CALIFORNIA COASTAL COMMISSION

**SUBJECT: REVISED FINDINGS ON CITY OF SAN DIEGO MAJOR LOCAL
COASTAL PROGRAM AMENDMENT #4-2000 (CENTRE CITY—NORTH
EMBARCADERO OVERLAY DISTRICT)**

SD LCPA #4-2000 (CENTRE CITY)
Selected Exhibits Relevant to
Revised Findings

VIEW CORRIDOR STREETS

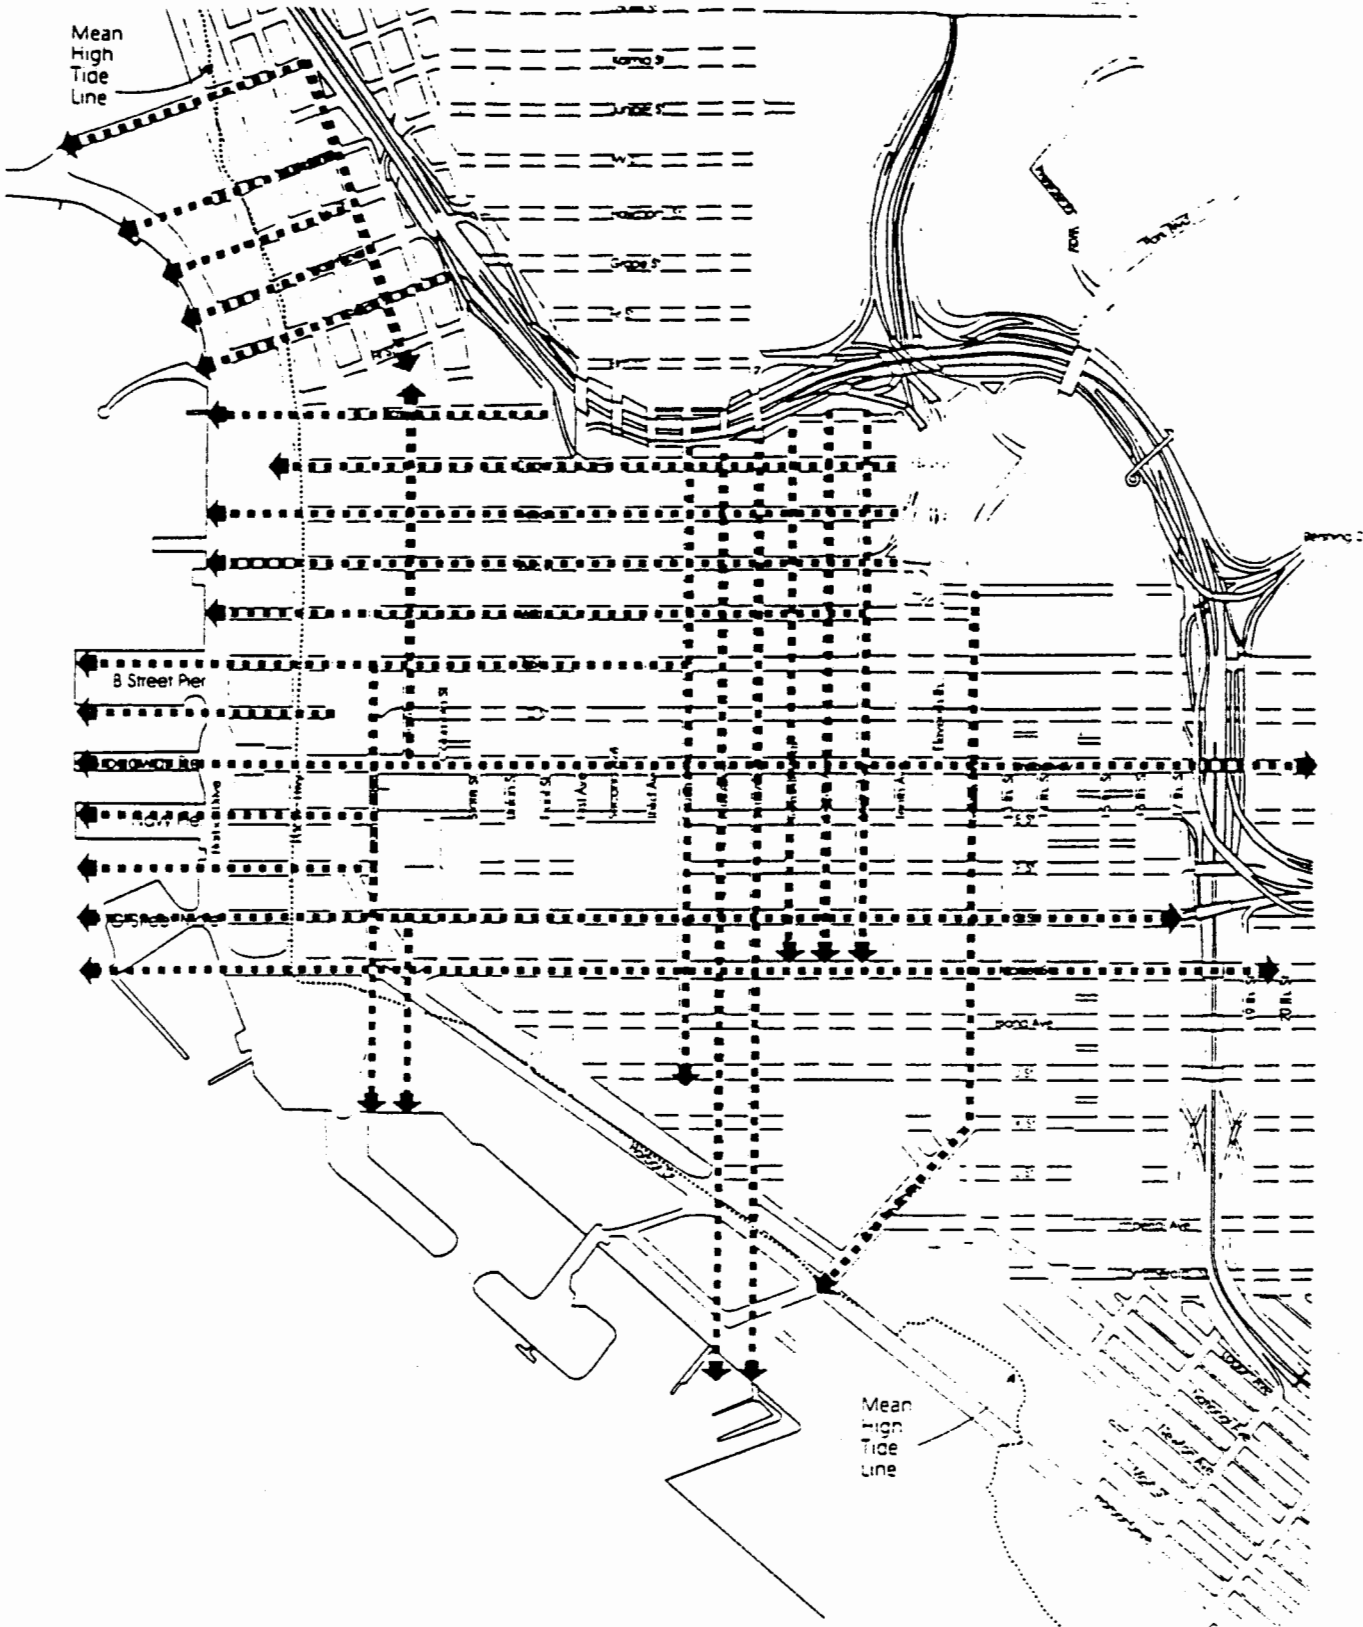
4. Figure 19, **VIEW CORRIDOR STREETS**, shall be revised to graphically depict Pacific Highway as a View Corridor Street from Date Street south to Pacific Highway's terminus (as shown on the existing Figure 19).

The plan would also make several changes to the existing View Corridors Streets shown on Figure 19. Ivy Street would be added as a View Corridor Street, and Pacific Highway is proposed to be removed as a view corridor. Designated view corridor streets are afforded special "stepback" protection to ensure that views from and along these streets are maintained. The City had originally proposed amending the View Corridors stepback table on page 45 of the LUP plan to alter the required stepbacks for several streets west of California Street, including Juniper, Hawthorn, Grape, Cedar, Ash, A, B, C, Broadway (both east and west of Kettner), E, F, and G. Since that time, the City has requested that the View Corridors table simply be deleted from the LUP, such that only the View Corridors stepback table in the PDO (as amended) would contain the required stepback distances and elevations (see Exhibit #15).

The proposed amendment includes the removal of Pacific Highway as a view corridor. Removal of the designation would also remove the requirement that development along Pacific Highway maintain a 15-foot stepback at elevation 50 feet. The City has

Very little of downtown San Diego is within the Coastal Zone, but those streets that are major coastal accessways should be afforded the protection of the view corridor designation. Pacific Highway, in particular, is the southernmost stretch of the Pacific Coast Highway that runs the length of much of California. While hardly the narrow, scenic corridor that PCH is in northern California, Pacific Highway will still be the street most people travel along the bayfront in downtown. Given that the Port Master Plan does not contain the setback protections typically afforded a major coastal access route, it becomes especially important that setbacks are preserved on the eastern side of the street. Thus, removal of Pacific Highway as a view corridor is not consistent with the visual protection policies of the Coastal Act.

Suggested Modification #4 eliminates the City's proposal to remove Pacific Highway as a designated view corridor in the Community Plan. Pacific Highway is currently a major coastal access route. As a result of the proposed amendment and the proposed PMPA #27, even greater amounts of traffic will be diverted onto Pacific Highway. Thus, it is particularly important that the visual quality of Pacific Highway be preserved. However, the suggested modification changes the minimum stepback amount from 15 feet to 25 feet, and allows the stepback to occur anywhere from 30 feet to 130 feet in elevation. This will allow the City some flexibility in designing buildings consistent with the stepback requirements of the Port District (which has jurisdiction over the western side of Pacific Highway) while still maintaining the view corridor designation as appropriate for a major coastal access route. As modified to retain the view corridor designation for Pacific Highway, the Commission finds the plan consistent with visual protection policies of the Coastal Act.

Figure 1

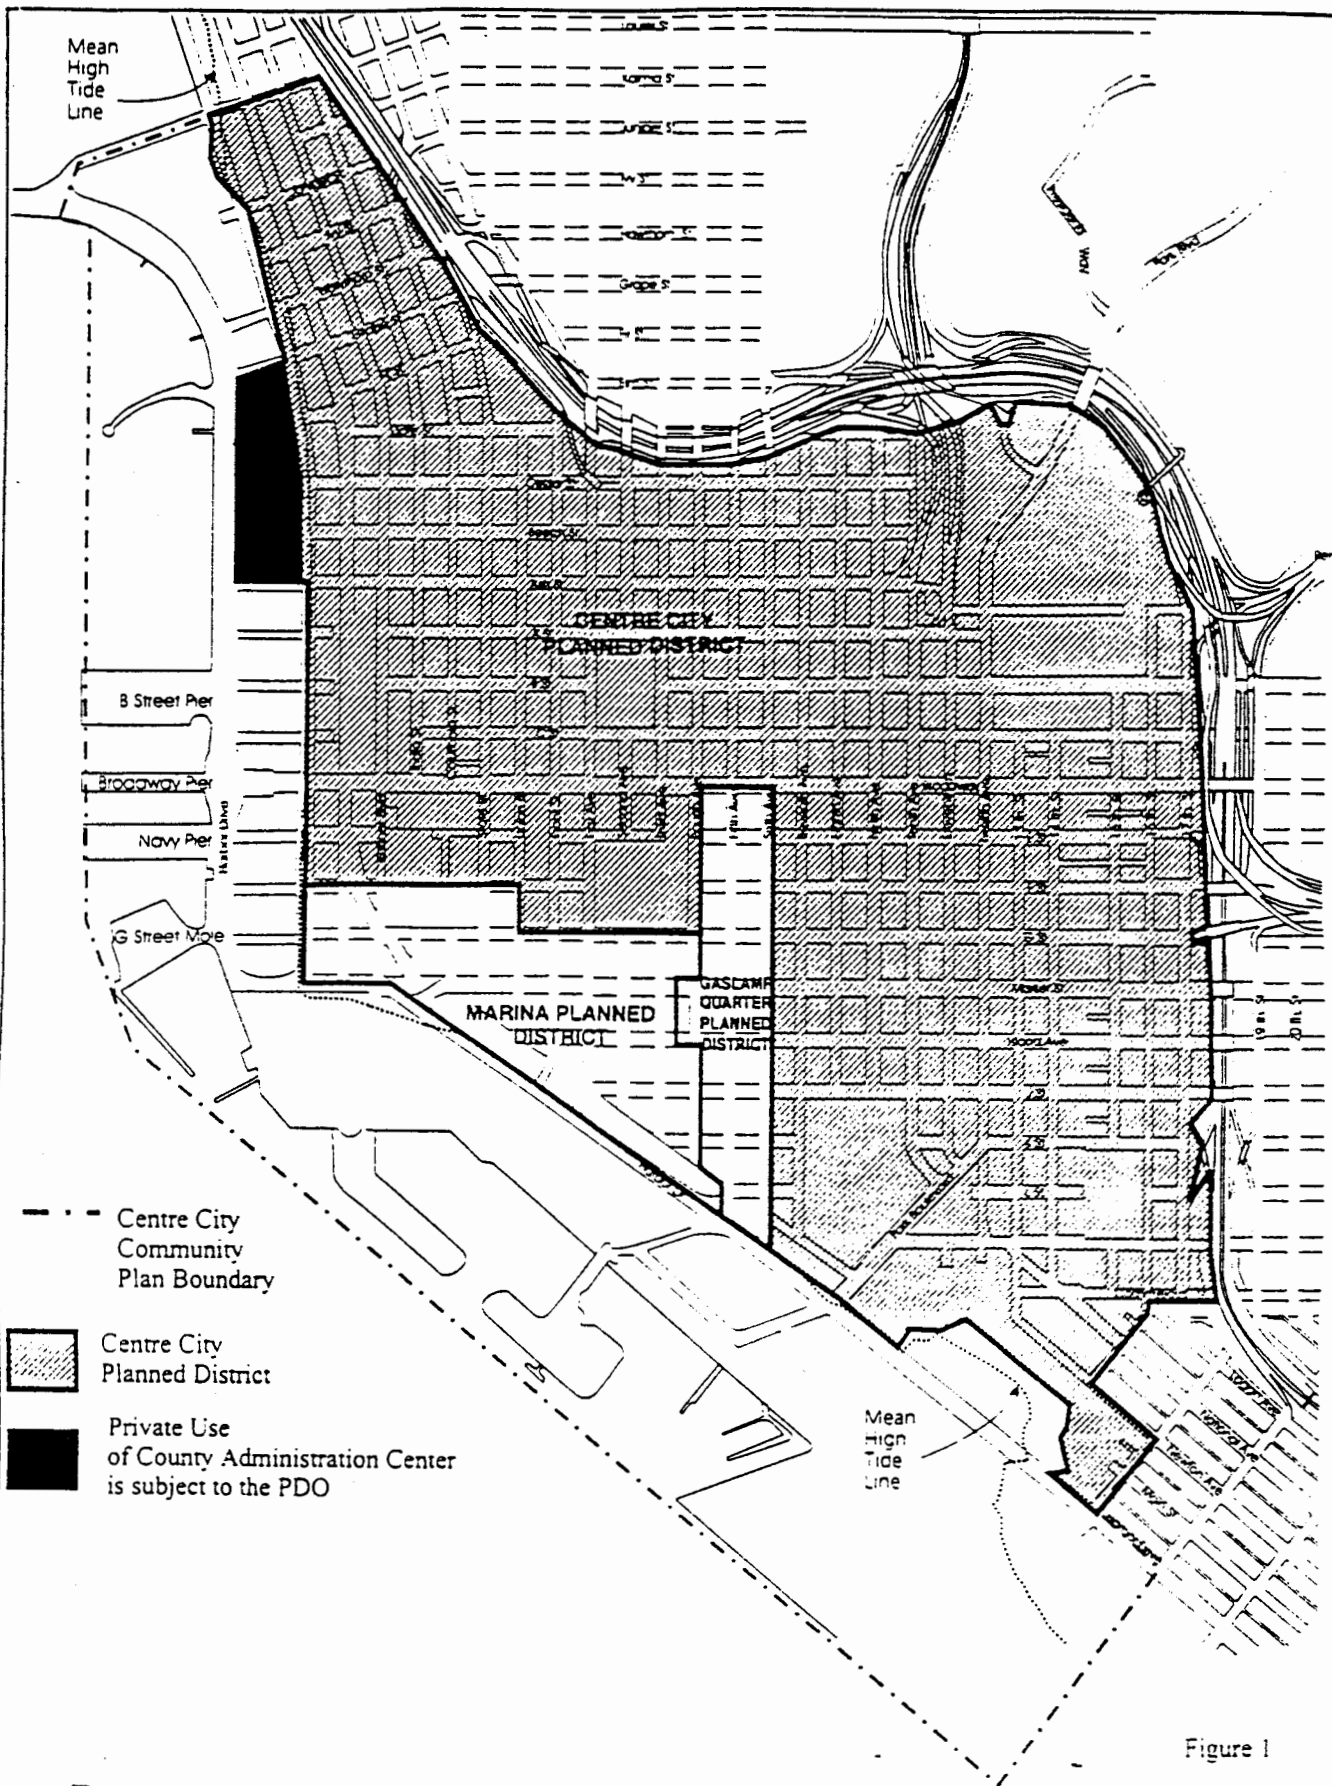
7. Figure 1, **Centre City Planned District Boundary**, the legend for the County Administration Center shall be revised as follows:

The proposed PDO contains two references to the standard of review for development at the County Administration Center that do not fully reflect the status of the certified LCP. Both the proposed Section 103.1903 and Figure 1, Centre City Planned District Boundary in the PDO contain language stating that private development at the location of the County Administration Center would be subject to the provisions of the PDO. (The County and the City have entered into an agreement excluding public development of the site from the provisions of the PDO). However, although private development is subject to the PDO, it is important to make clear that when the Commission certified the Centre City/Pacific Highway Corridor segment of the City's Land Use Plan in January 1988, the Commission deferred certification of the County Administration Center area, finding that the zoning proposed for the area at the time (Central Business District), was not consistent with the certified Land Use Plan. The Commission also noted that there are jurisdictional questions raised about the City and County planning and regulatory roles on this site that supported deferred action and further study.

The two references in the proposed PDO do not fully describe the standard of review for development at the County Administration Center. When the Centre City Implementation Plan was approved by the Commission in 1988, certification of the County Administration Center site was deferred and remains with the Commission's jurisdiction. Private development on the site is subject to the PDO, but approval of a coastal development permit on the site is subject to the Chapter 3 policies of the Coastal Act, with the PDO used only as guidance. Therefore, Suggested Modifications #6 and #7 revise both the proposed text and Figure 1 of the PDO to make it clear that the PDO does apply to the County Administration Center, but the site is an area of deferred certification.

Proposed
Building Height-North Embarcadero

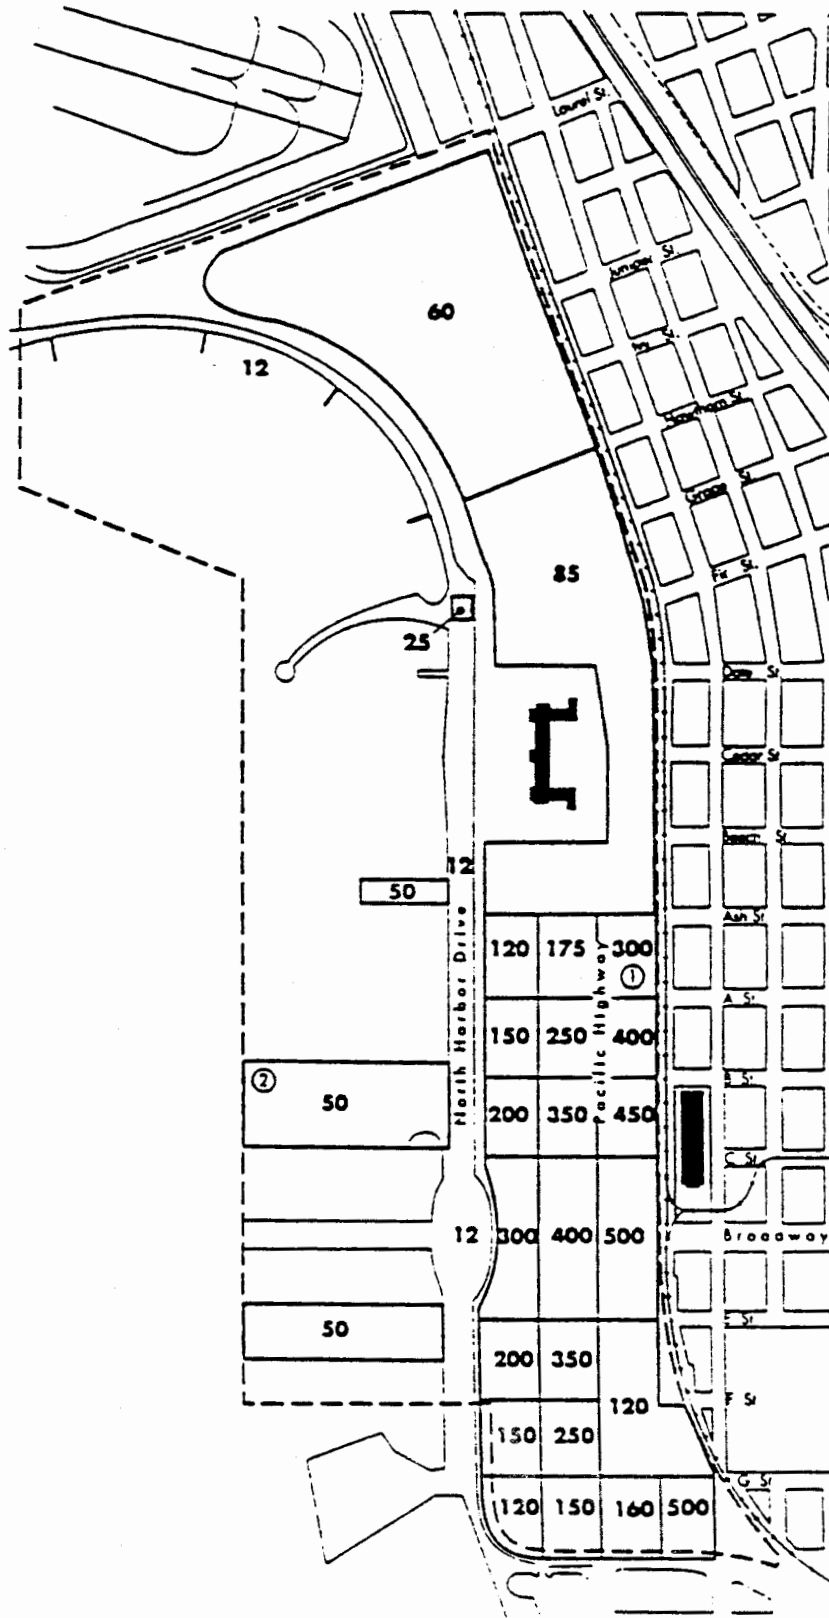
8. The proposed Figure 4, **Building Height-North Embarcadero**, shall be revised as follows:

The amendment would add a new exhibit, "Building Height-North Embarcadero" as Figure 4 to the PDO. The figure includes proposed height maximums for the North Embarcadero area, including four blocks which fall under the Marina PDO, and the blocks west of Pacific Avenue, which are under the jurisdiction of the Port District (or in the case of federal lands, are white-holed areas not covered by any certified LCP). Currently, there are no height limits in the Centre City PDO, only Floor Area Ratios, which are not proposed to be changed with the subject amendment.

The amendment includes a new exhibit, "Figure 4, Building Height-North Embarcadero." The heights apply to the entire Waterfront District, including the blocks west of Pacific Avenue, which are under the jurisdiction of the Port District (or in the case of federal lands, are white-holed areas not covered by any certified LCP). Currently, there are no height limits in the Centre City PDO, only Floor Area Ratios, which are not proposed to be changed with the subject amendment.

Furthermore, a number of the heights proposed in the new exhibit in the Centre City PDO are not consistent with those proposed in the PMPA. The existing Port Master Plan does not have height limitations for buildings in the North Embarcadero region. The proposed PMPA for the North Embarcadero states that building height limits for the Lane Field parcel "range from 400 feet to 200 feet sloping towards the bay." The Centre City PDO's proposed heights for this parcel are 350 feet to 200 feet (north of C Street), and 400 feet to 300 feet (south of C Street), sloping towards the bay. The City's proposal would impose height limitations for the blocks north of B Street where the PMPA does not impose any height restrictions. The City's proposal places a 50 foot height limit on Navy Pier and an existing pier north of Ash Street, which would conflict with the proposed PMPA's height limitation of 12 feet for this area, and would be inconsistent with the view

As discussed above, the proposed new Figure 4, "Building Height-North Embarcadero," (Figure 4) includes height limits for areas within the Port District's permit jurisdiction. In general, it is problematic to place specific development standards on properties outside the City's jurisdiction, since the standards cannot be implementing policies of a Land Use Plan which does not apply to the area. More importantly, several of the proposed heights are inconsistent with the proposed PMPA, which *is* the standard of review for the area. However, the City feels strongly that identifying height limits for the area will be a useful planning tool for coordinating development in the area with the Port jurisdiction. Thus, Suggested Modification #8 changes several of the height designations so that they do not conflict with the Port's standards. In addition, the exhibit will be labeled with a disclaimer stating that all height limitations west of Pacific Highway are for planning purposes only.

The remaining height limits proposed are located on the one-block wide area between Pacific Highway and California Street. The City has also asked that one revision be made to their original submittal to designate a height limit of 450 feet on the block between E and F Street, between Pacific Highway and California Street. The proposed limits have been designed to be consistent with the goals of the proposed plan that development along shoreline and Harbor Drive "be low in scale and intensity and increase in stepped building envelopes further upland...this concept of 'stepped intensity and scale' will be implemented through floor area ratios (FARs) and other development characteristics..." No revisions to the existing FARs are proposed. Currently, there are no height limits in the Centre City PDO. Thus, the proposed height limits could potentially affect the appearance of new buildings (with an upper height limit, a building would have to be bulkier to achieve the same FAR as a taller building), but as discussed, the proposed view corridor stepbacks, as modified, will adequately protect the visual quality of the area consistent with the proposed Community Plan. Suggested Modification #8 would revise the City's amendment to place a 450-foot height limit on the block between E and F Street, as requested by the City.
